PSE State Diagram – Sequence 3

Considerations for Staggered Detection and Power-on of Dual-Signature PDs.

IEEE 802.3bt Task Force

Oct 2015

Sequence 3:

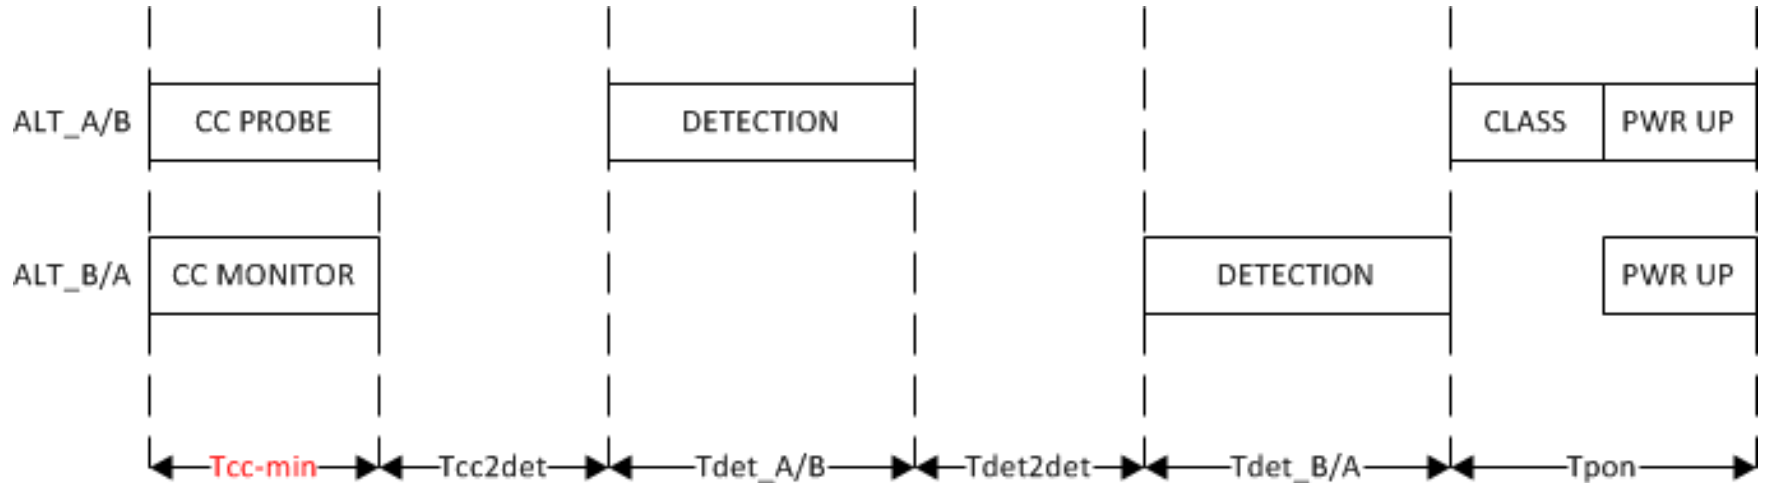
Staggered Detection and Power-up of DS PDs.

CC → Det/CIs/Pwr ALT_A/B → Det/CIs/Pwr ALT_B/A

CC → Det/Cls/Pwr Alt_A/B (DS PD)

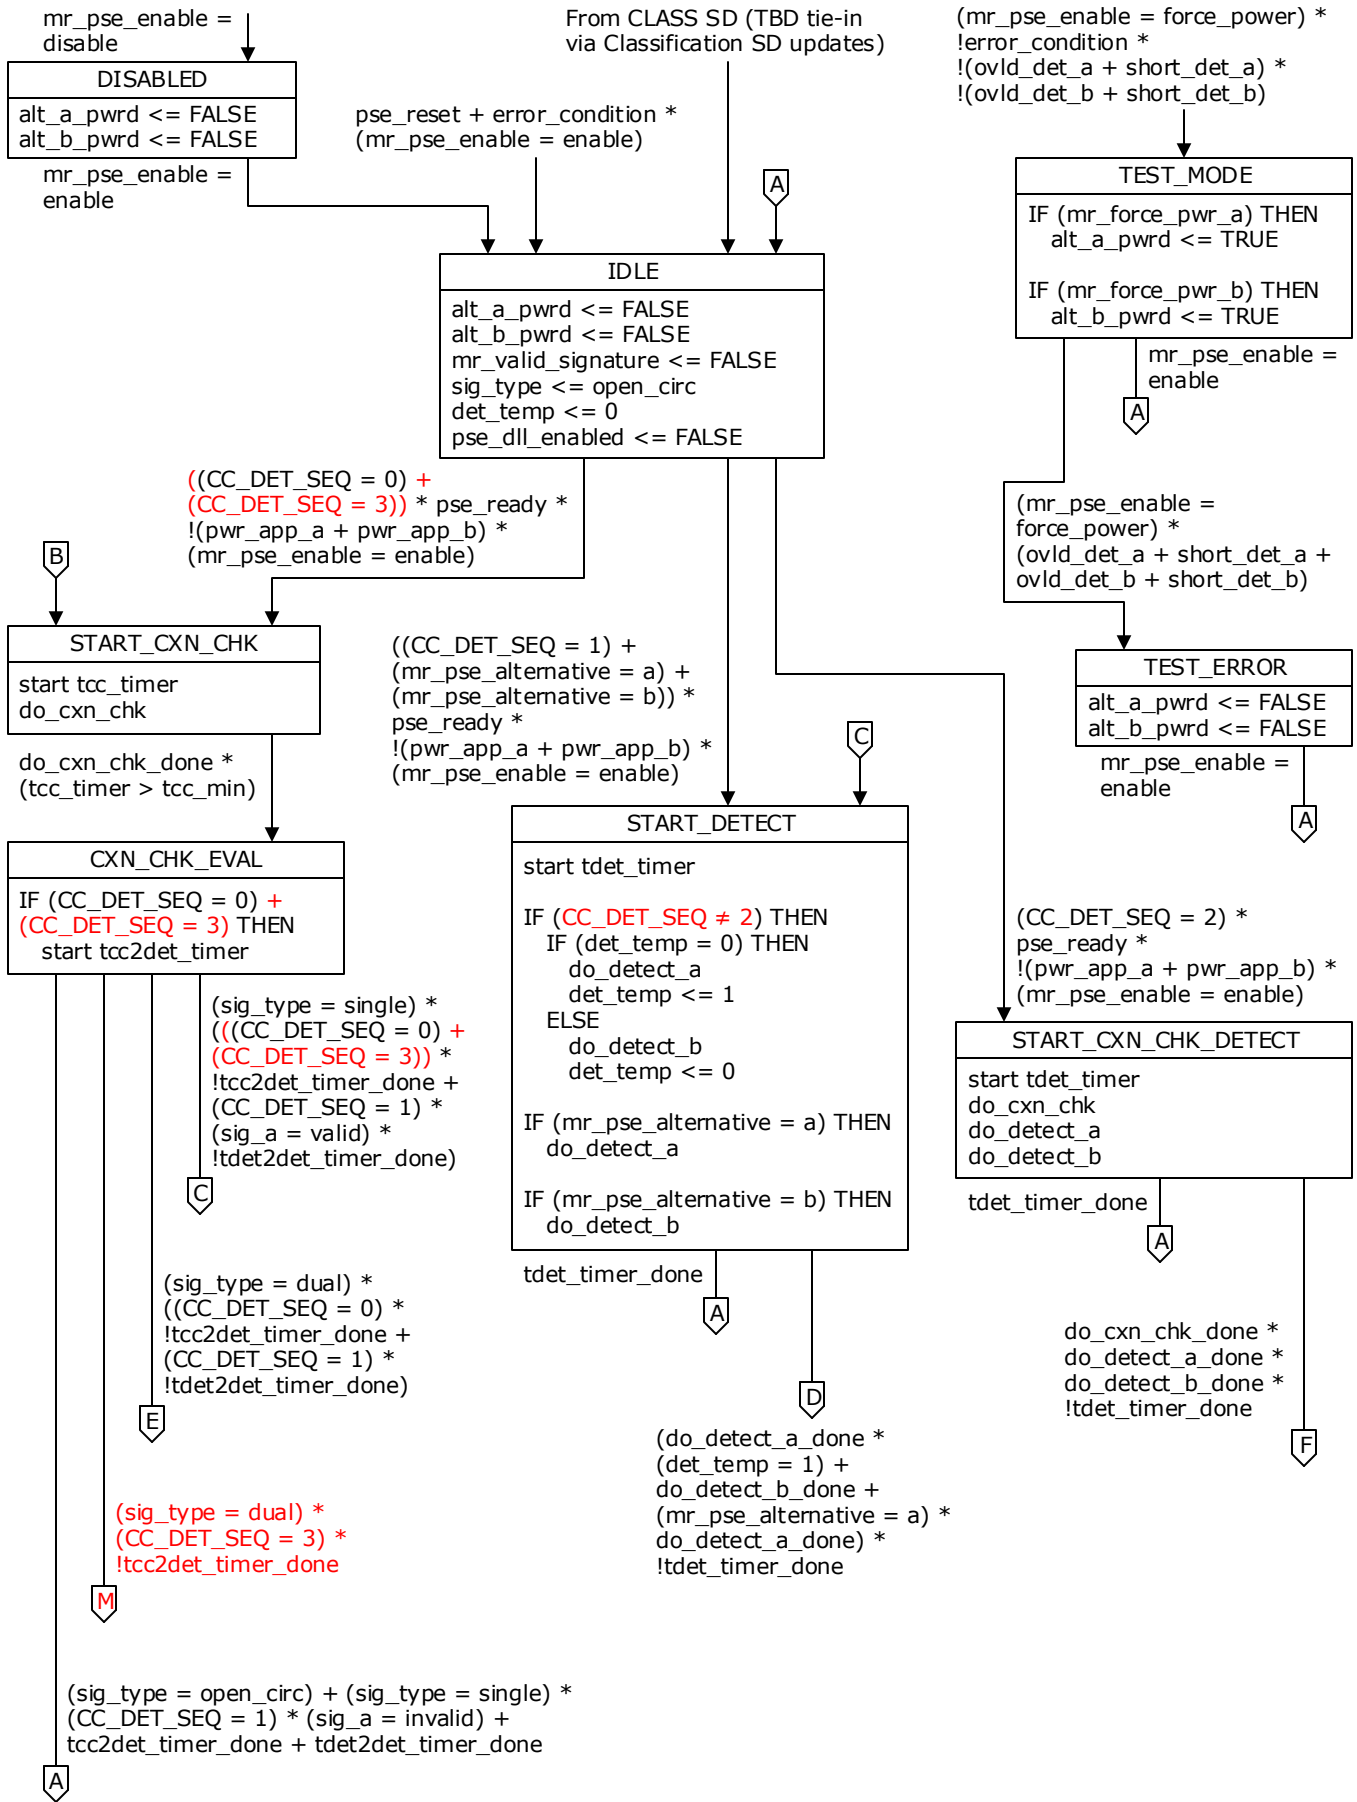
T_{cc2det} is enforced for the first pairset to successfully power.

T_{det} and T_{pon} are enforced for each pairset.

Alternative A/B Parity:

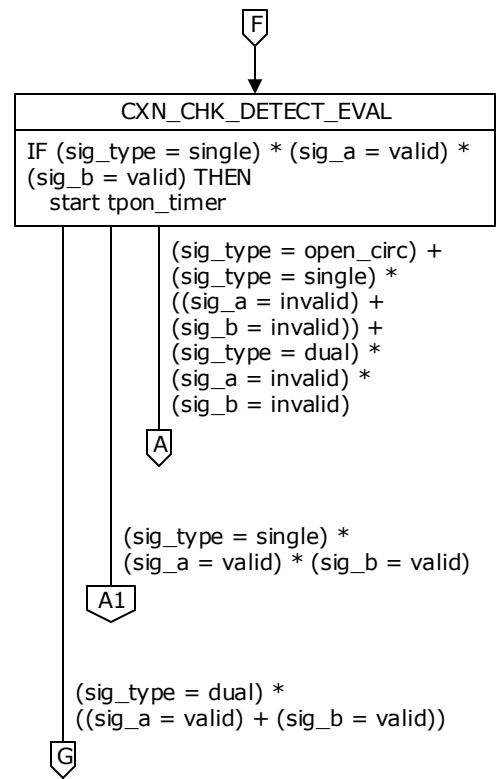
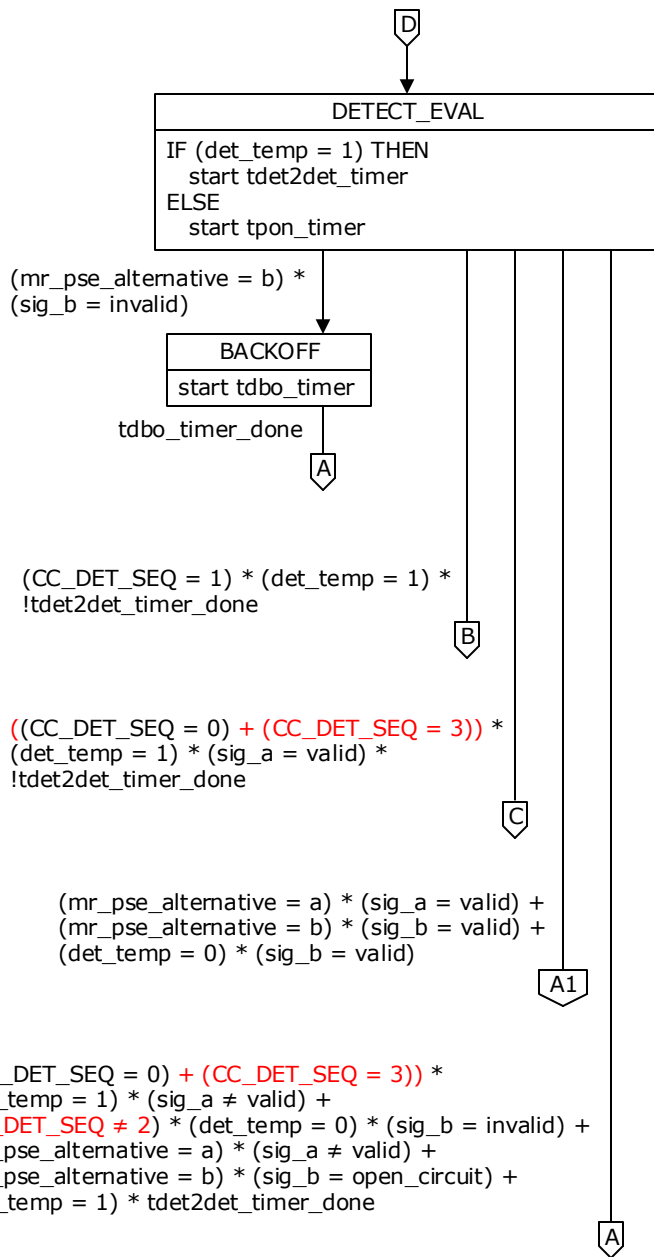
Treatment of Alt-A and Alt-B are interchangeable for the purposes of the State Diagram

Add the following text in section 33.2.4.1:

“In the Type 3 and Type 4 state diagram, Alternative A and Alternative B are depicted as serving distinct roles during 4-pair operation. In any implementation, the behaviors of the Alternatives may be reversed as long as the roles are established in IDLE and shall be maintained in every other state.”
